RE: **Lot 27 Block 8 Unit 22 SAD 228
6311 Petirrojo NW
Volcano Cliffs Subdivision
Grading and Drainage Plan
Engineers Stamp Date 5/10/2021 (D10D003E27)**

Based upon the information provided in your submittal received 5/7/2021, this plan is approved for Grading Permit.

DRAINAGE AND TRANSPORTATION INFORMATION SHEET (REV 6/2018)

ENGINEER'S SEAL	Lot 27 Blk 8 Un 22 VC 6311 Petirrojo Road NW	DRAWN BY DEM
DAVID SOULE NEW MEXICO REGISTERED PROFESSIONAL ENGINEER 14522	GRADING AND DRAINAGE PLAN	DATE 5-5-21
5/10/21	Rio Grande Engineering ALBUQUERQUE, NM 87199 (505) 321-9099	Lot 27 Blk 8 Un 22 VC.DWG
DAVID SOULE P.E. #14522		SHEET # C1
		JOB #

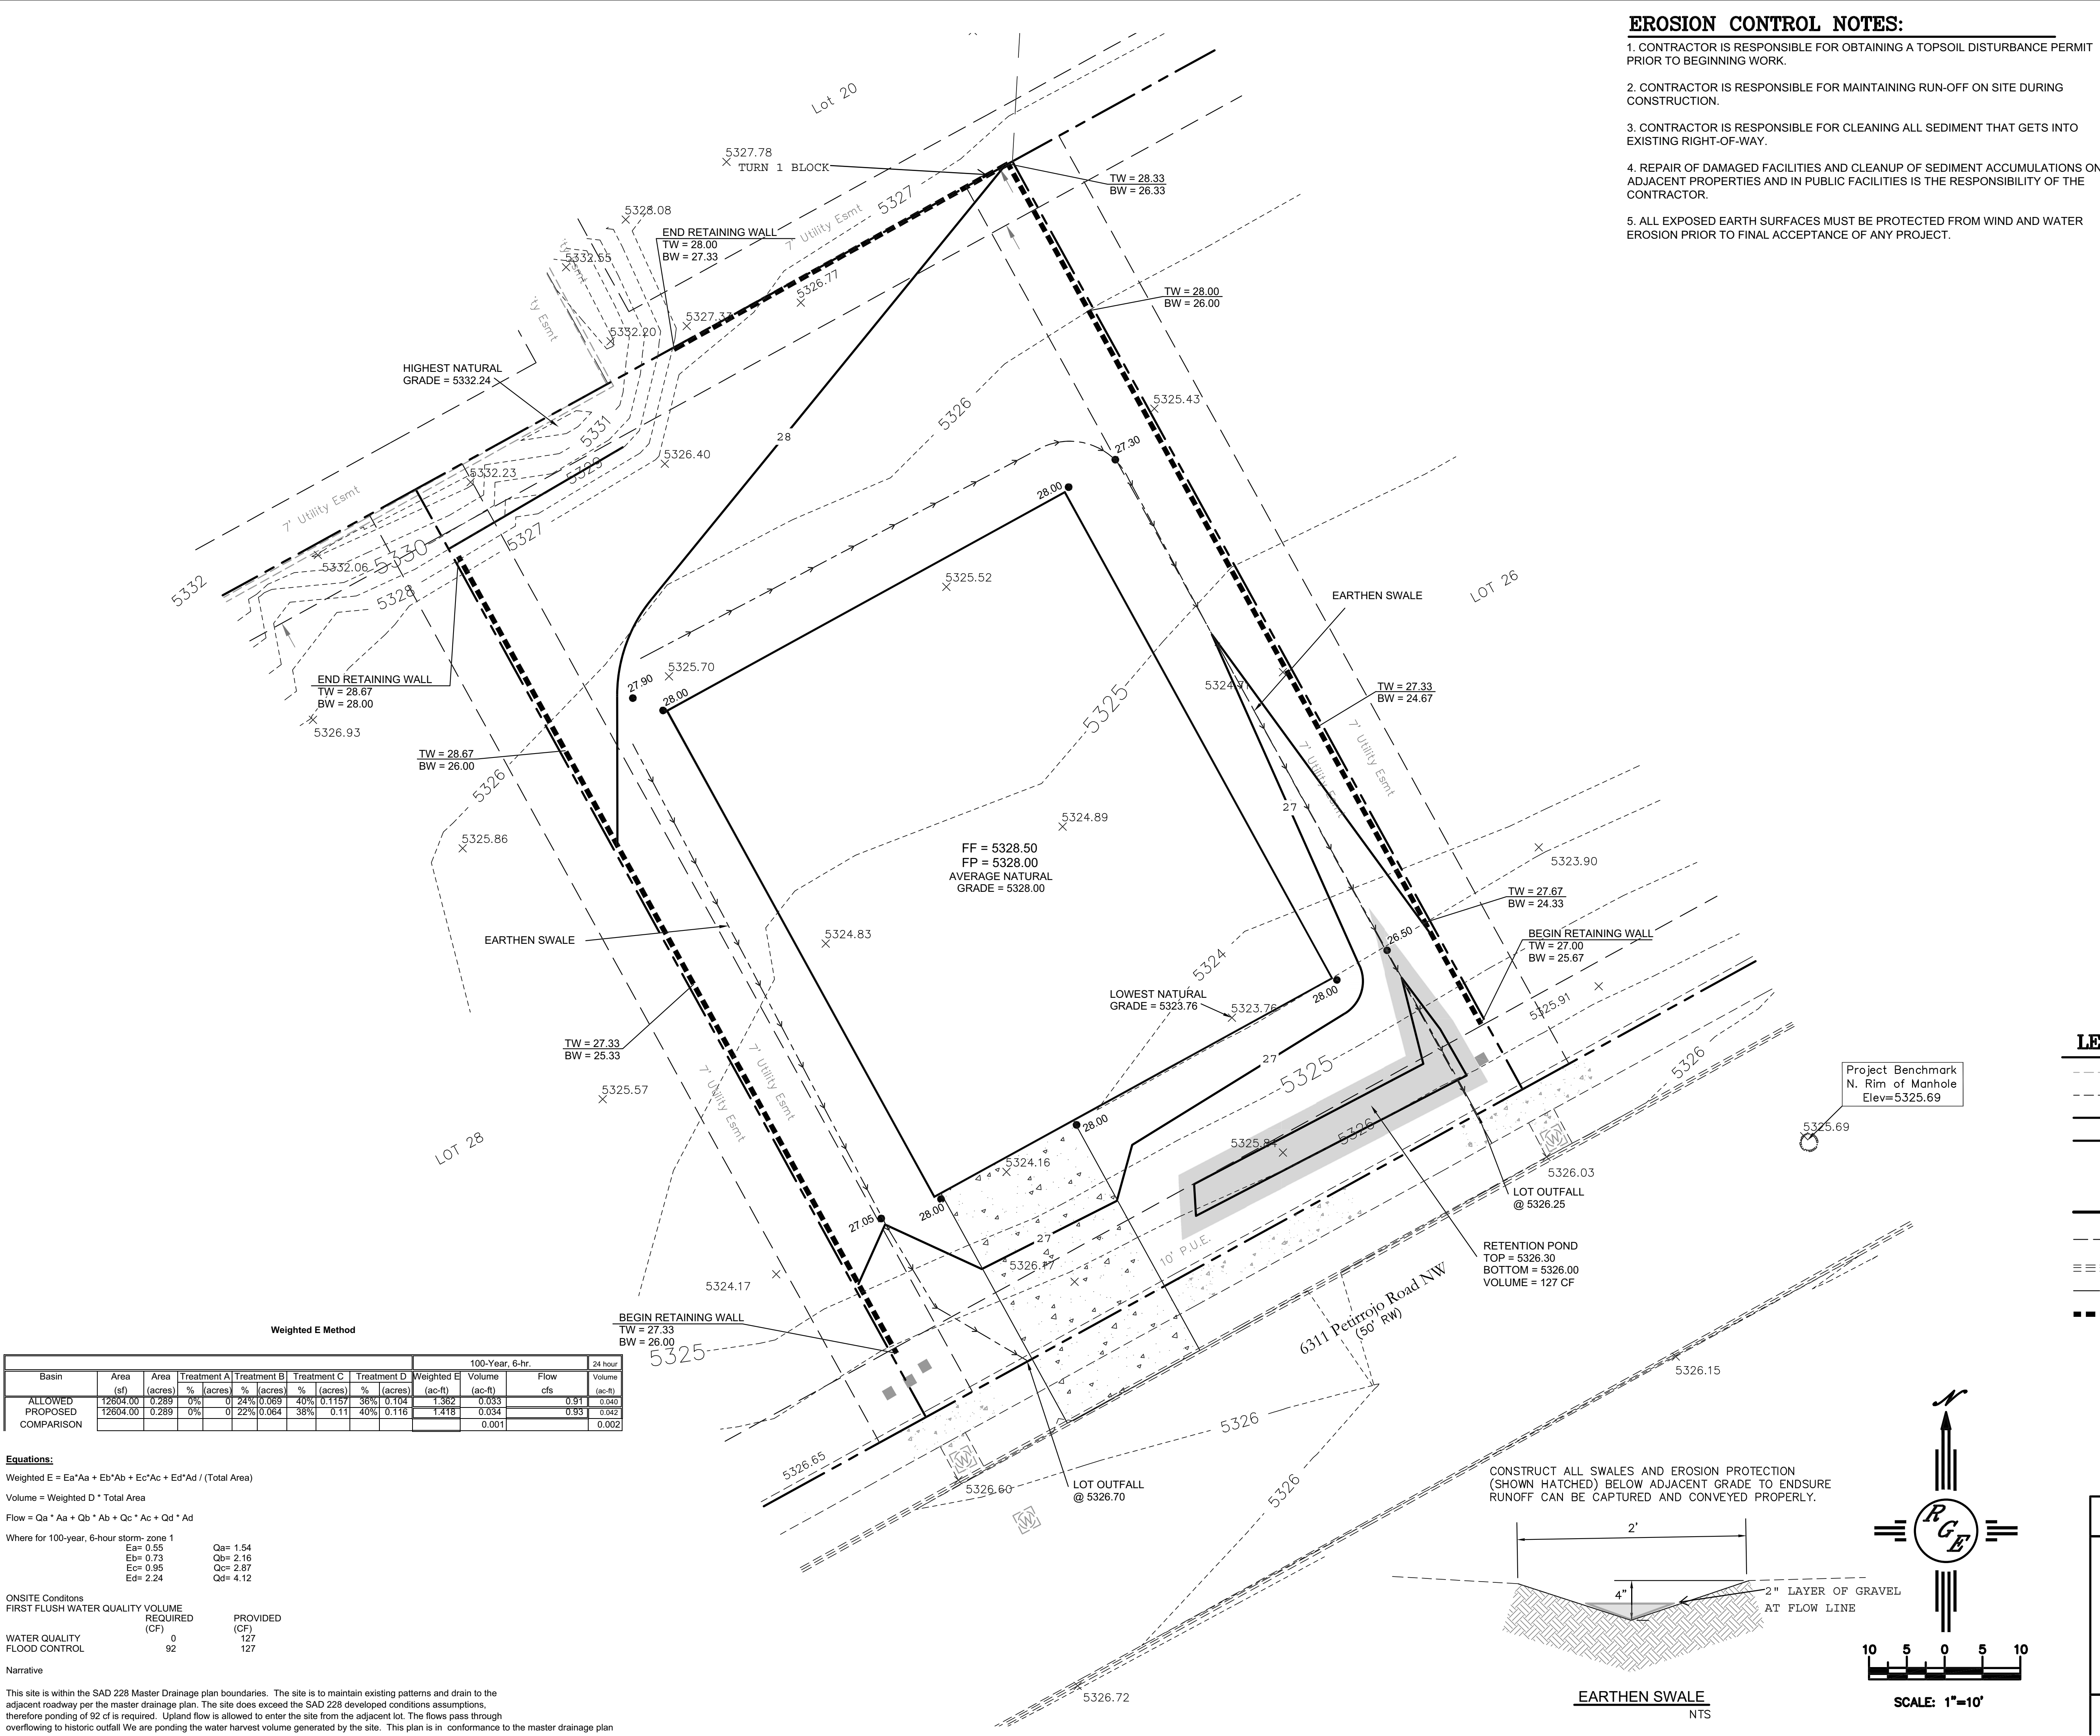
Prior to Building permit approval a Pad Certification will be required, provided by the Engineer or a registered Land Surveyor.

Advise the owner contractor not to use dirt as a ramp to climb the curb, use lumber or crusher fines for this purpose.

Reiterate to the Owner/Contractor that a separate permit for a garden/retaining wall must be obtained with the approved G&D plan and Pad Certification. Also, if a swimming pool is to be placed the grading and drainage plan will change and will need to be resubmitted.

Prior to Certificate of Occupancy release, Engineer Certification per the DPM checklist is required.
